**Maine Maritime Academy  
Castine, Maine**

**Pier Upgrades and Waterfront Improvements Project  
March 1, 2024  
ADDENDUM NO. 3**

7 SUMP PUMP  
E-702 NTS

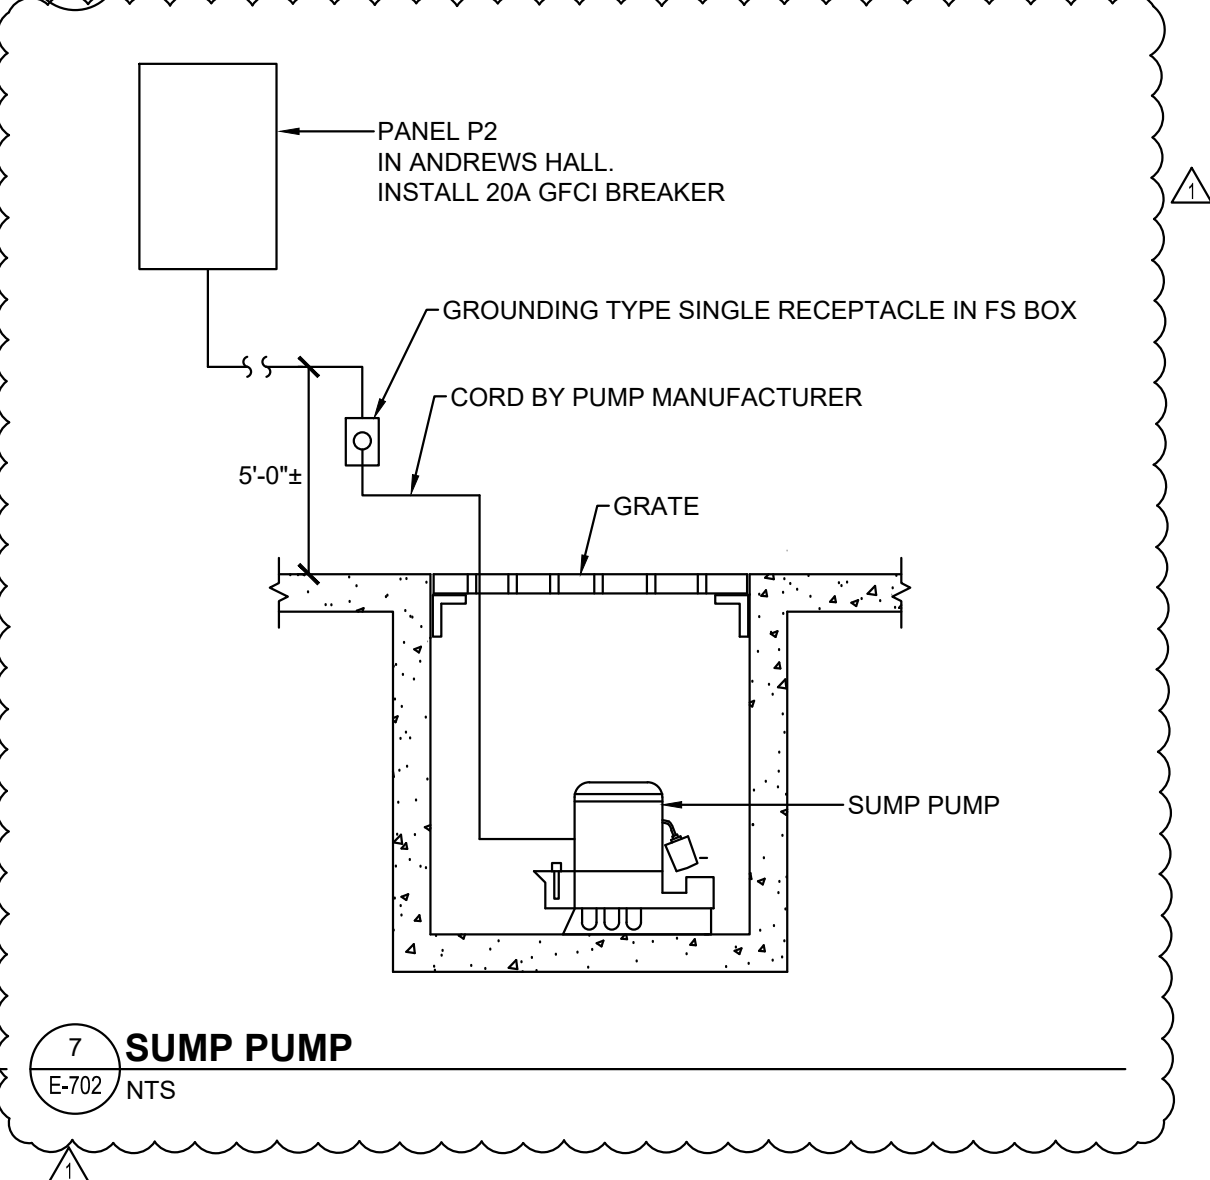
- g. Updated drawing notes to add clarity to the shore power outlet changes.
- 30. E-702 Electrical Details
  - a. Added STMH-01 sump pump detail.
- 31. E-801 Electrical Schedules
